FLYING HORSE NORTH
COUNTY OF EL PASO, STATE OF COLORADO
IRRIGATION RESERVOIR EMBANKMENT

<p>48 HOURS BEFORE YOU DIG, CALL UTILITY LOCATORS</p> <p>811</p> <p>UTILITY NOTIFICATION CENTER OF COLORADO IT'S THE LAW</p> <p>THE LOCATIONS OF EXISTING UNDERGROUND UTILITIES ARE SHOWN IN AN APPROXIMATE WAY ONLY. THE CONTRACTOR SHALL DETERMINE THE EXACT LOCATION OF ALL EXISTING UTILITIES BEFORE COMMENCING WORK. THE CONTRACTOR SHALL BE FULLY RESPONSIBLE FOR ANY AND ALL DAMAGES WHICH MIGHT BE CAUSED BY HIS FAILURE TO EXACTLY LOCATE AND PRESERVE ANY AND ALL UNDERGROUND UTILITIES.</p>	NO. REVISION		DATE	<p>REVIEW:</p> <p>PREPARED UNDER MY DIRECT SUPERVISION FOR AND ON BEHALF OF CLASSIC CONSULTING ENGINEERS AND SURVEYORS, LLC</p> <p>MARC A. WHORTON, P.E. #37155</p> <p>DATE</p>	<div style="text-align: center;">  <p>CLASSIC CONSULTING ENGINEERS & SURVEYORS</p> </div> <p>619 N. Cascade Avenue, Suite 200 (719)785-0790 Colorado Springs, Colorado 80903 (719)785-0799(Fax)</p>	<p>FLYING HORSE NORTH IRRIGATION RESERVOIR EMBANKMENT</p> <p>WELL SITE / TEST REPORTS</p>

CLASSICSM CONSULTING ENGINEERS & SURVEYORS	FLYING HORSE NORTH IRRIGATION RESERVOIR EMBANKMENT				
	PUMP STATION PLAN / DETAILS				
	DESIGNED B

DRAWING NO. PRVT12023 09/15/2016

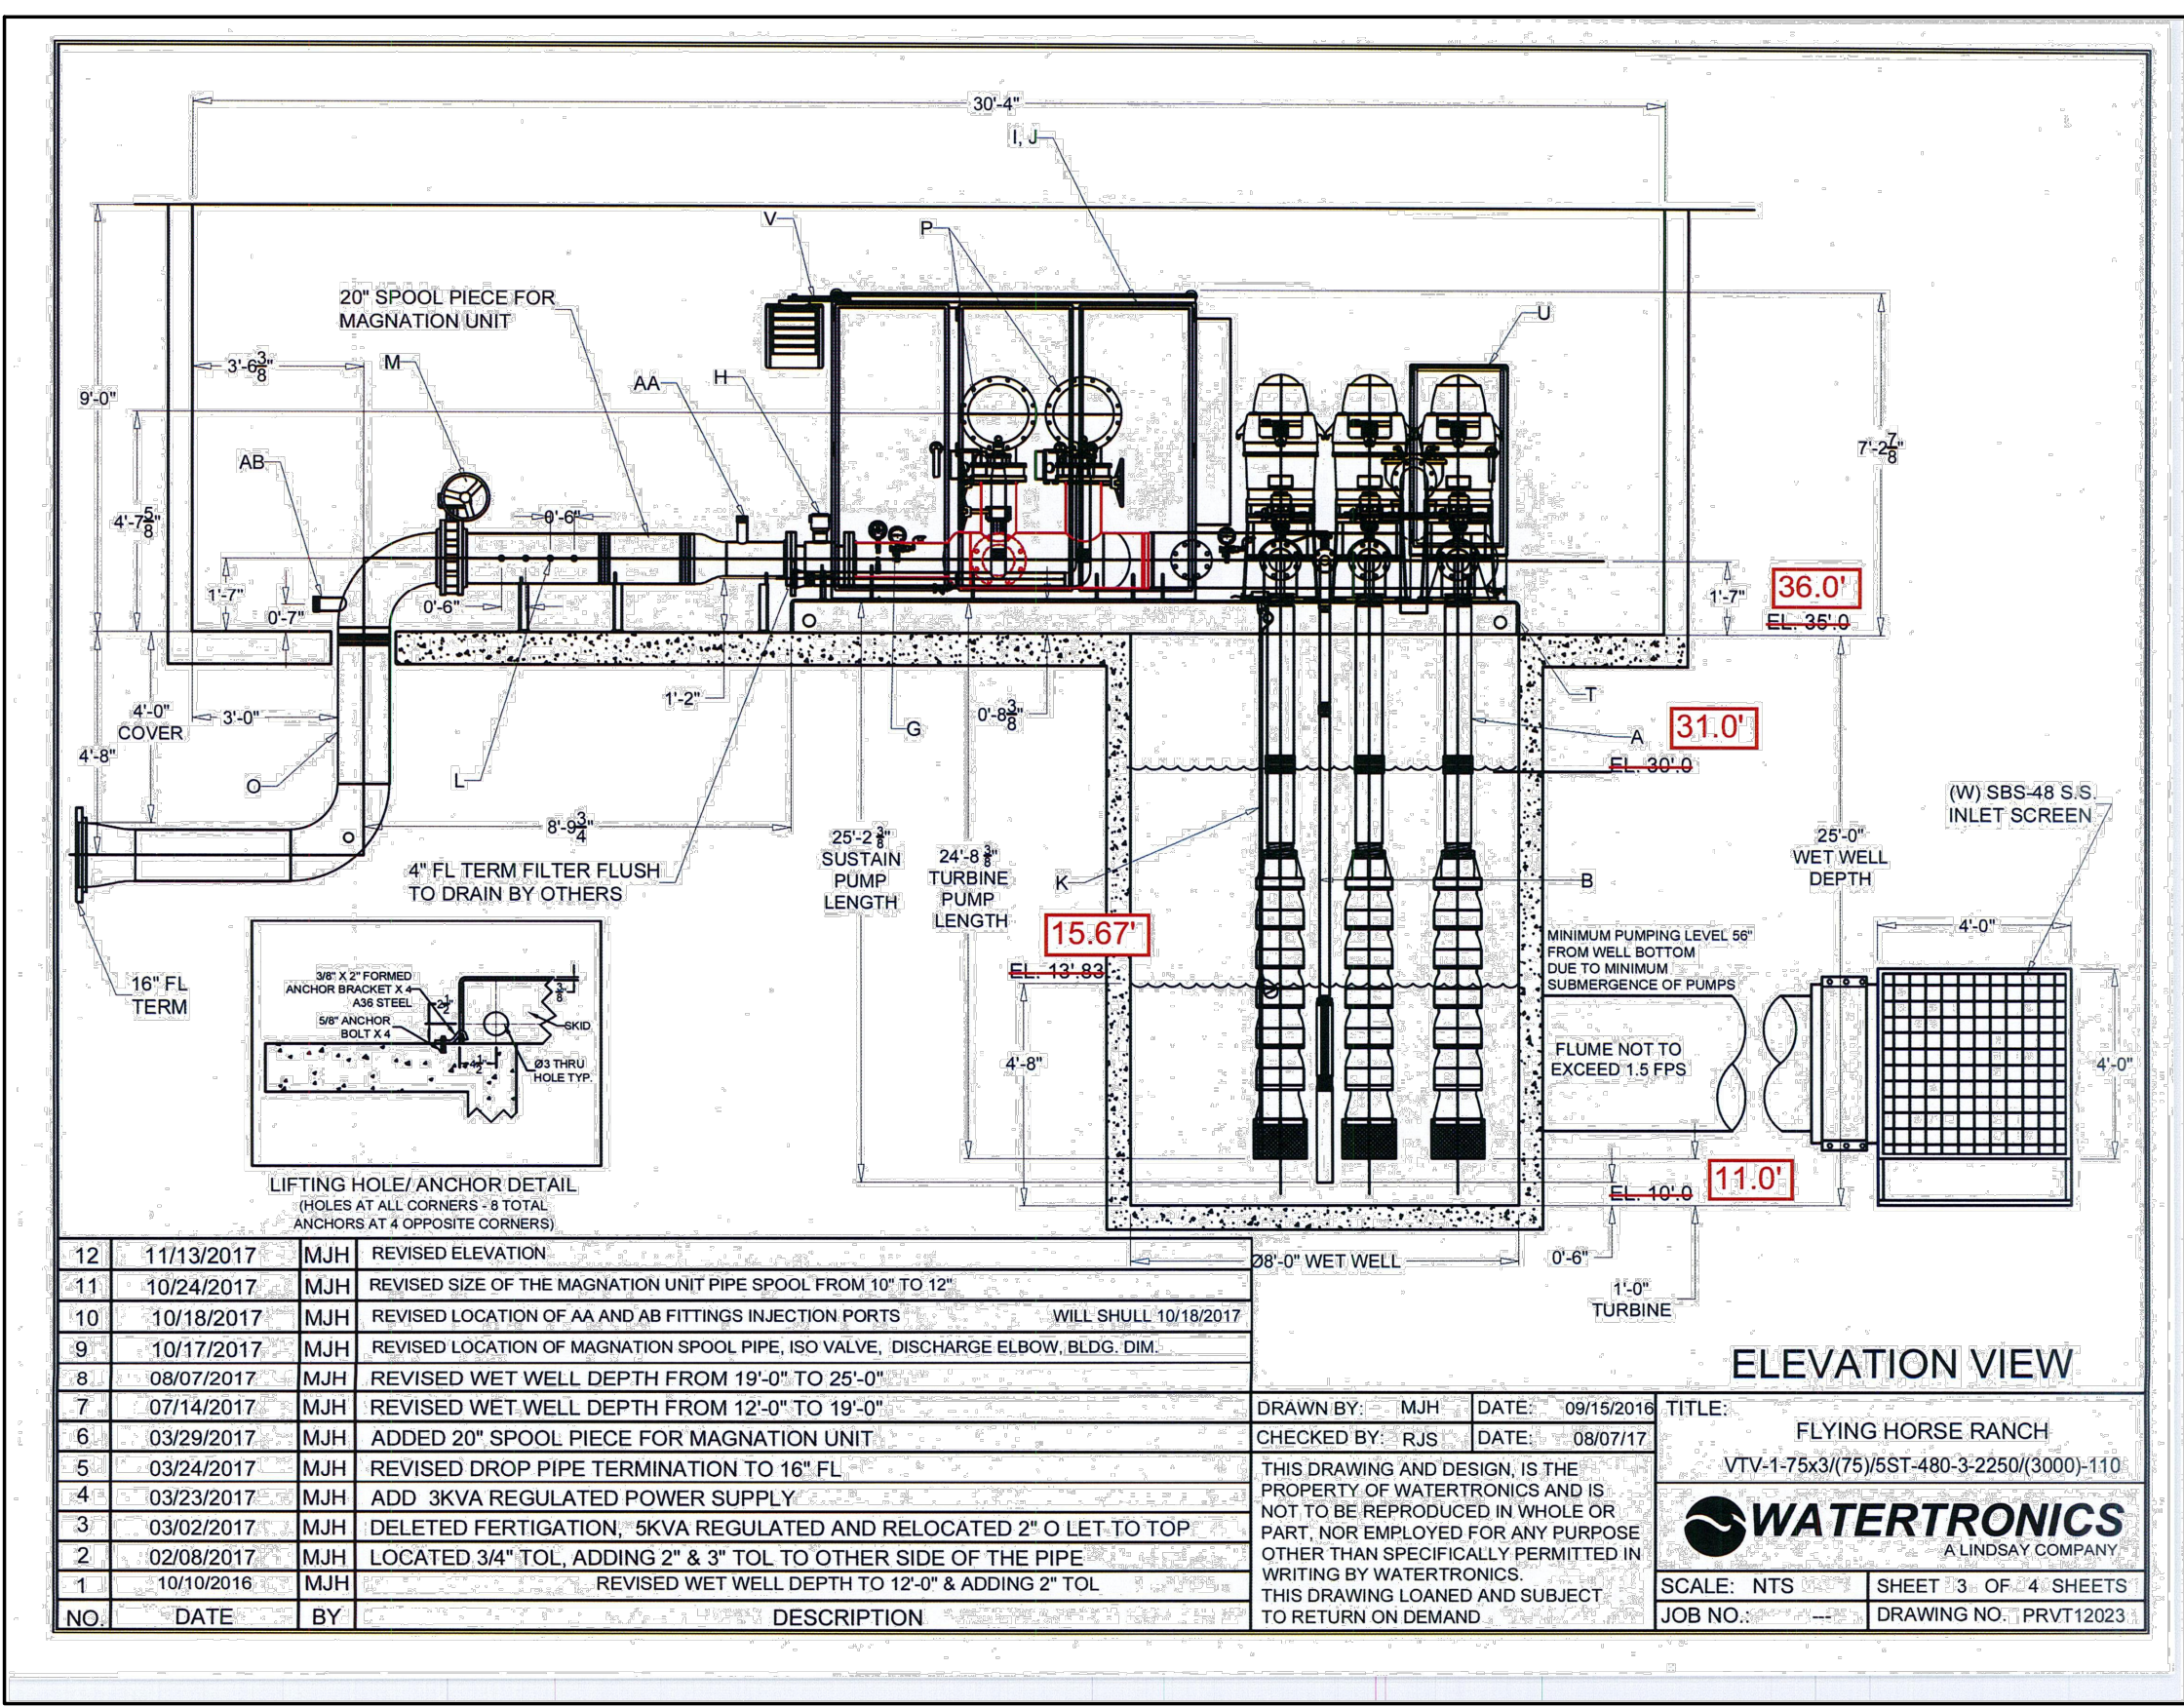
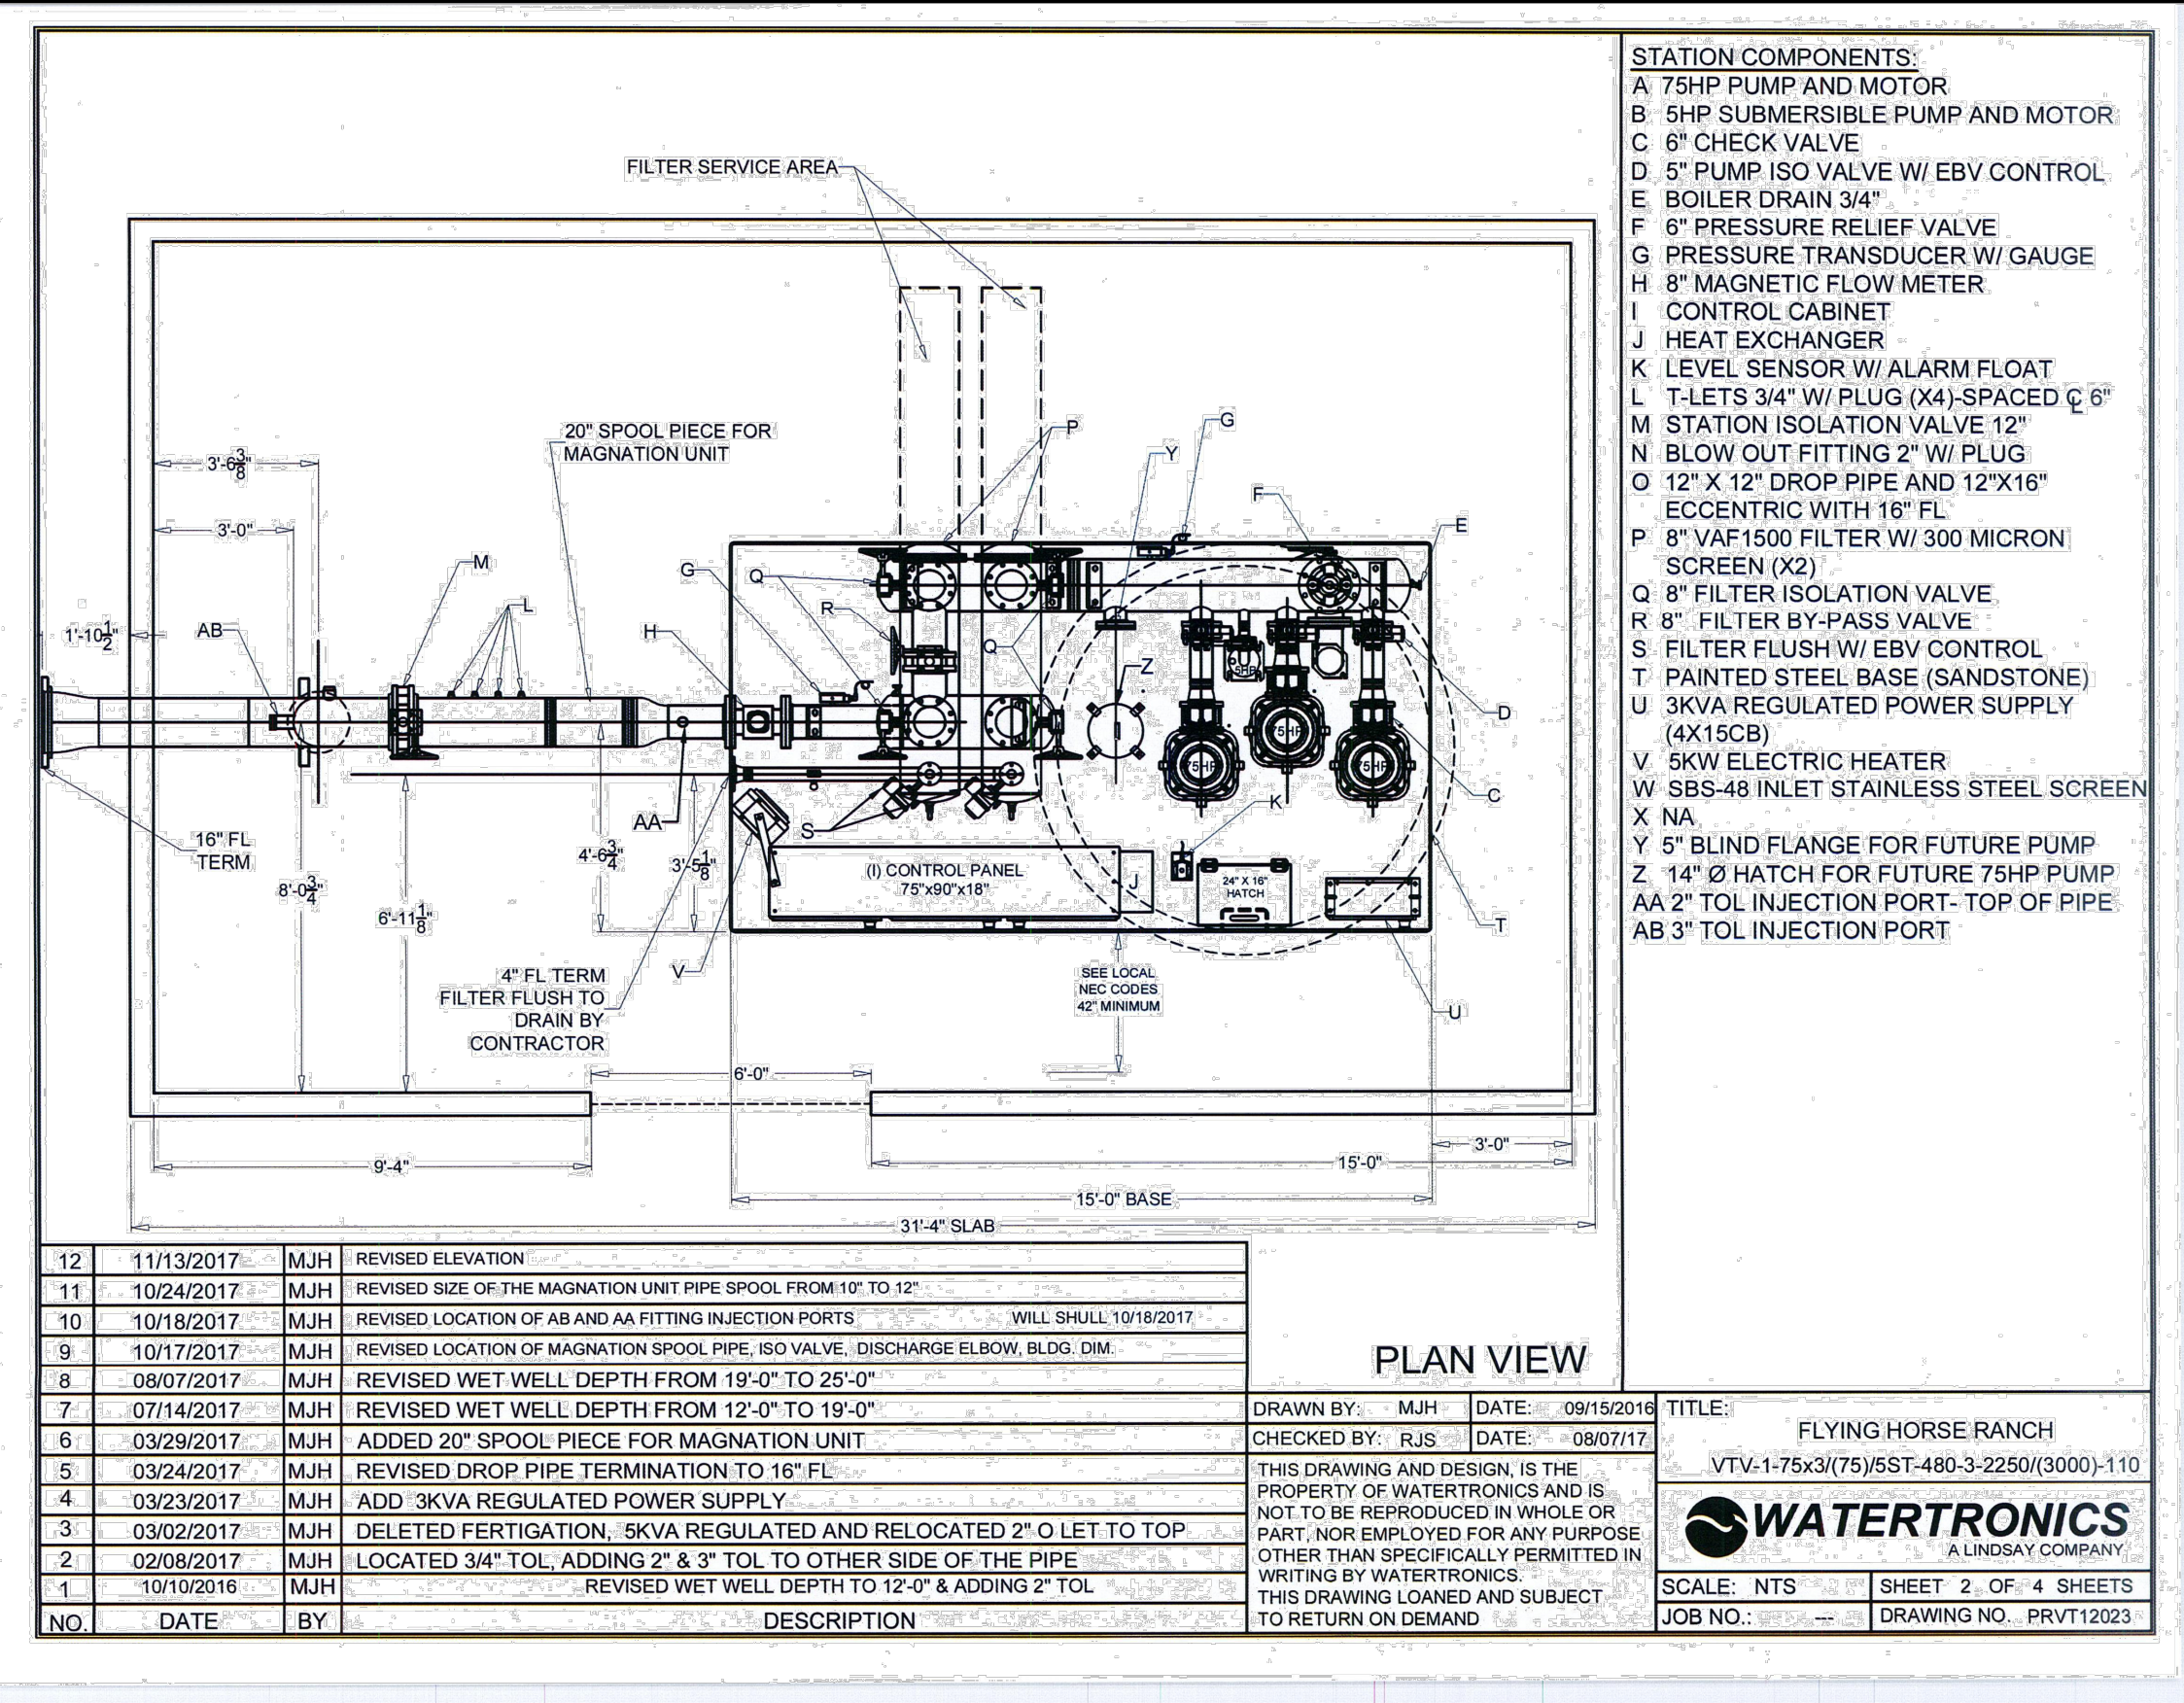
1. MIN. WATER LEVEL IN THE WET WELL 56" FROM THE BOTTOM
2. NORMAL WATER LEVEL AT THE WET WELL ??
3. MAX/HIGH WATER LEVEL IN THE WET WELL ??
4. TO DRAIN THE BOND COMPLETELY THE BOTTOM OF THE BOND NEED TO BE LOWER THAN THE BOTTOM OF WET WELL !

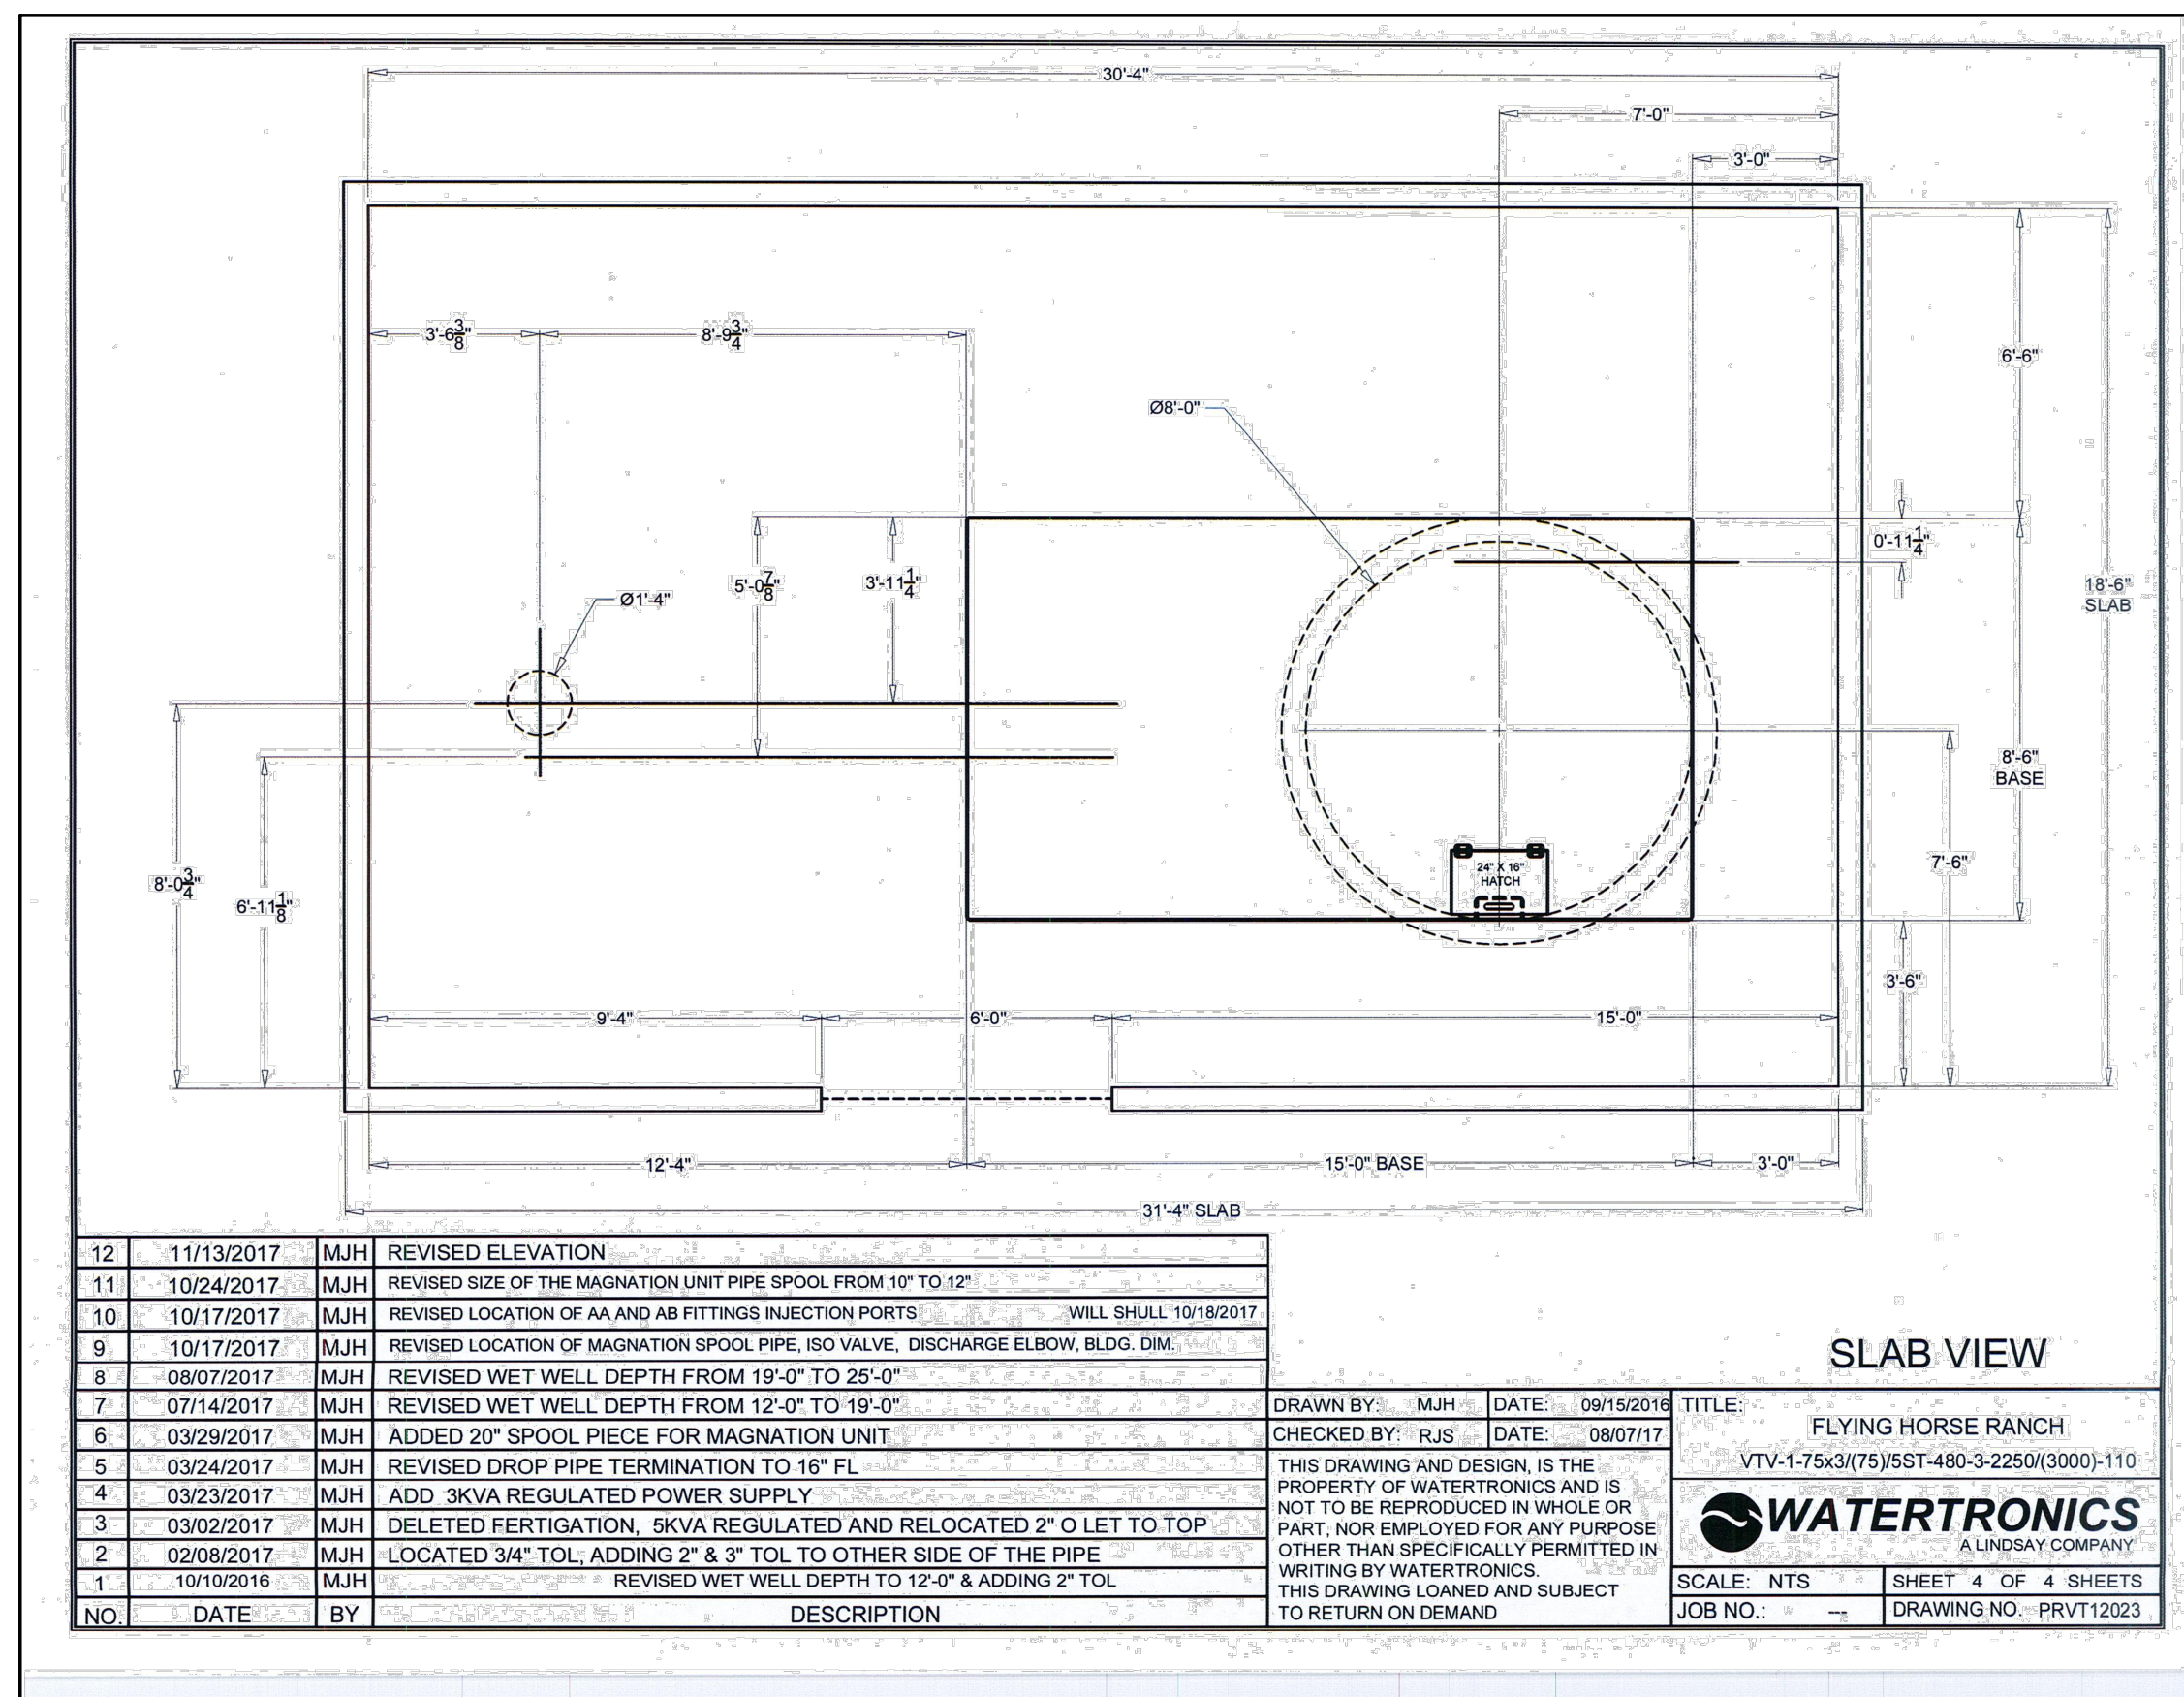
***NOTE: The invert elevation of the 30" PVC is not indicated on the detail drawing. To be confirmed by contractor.**
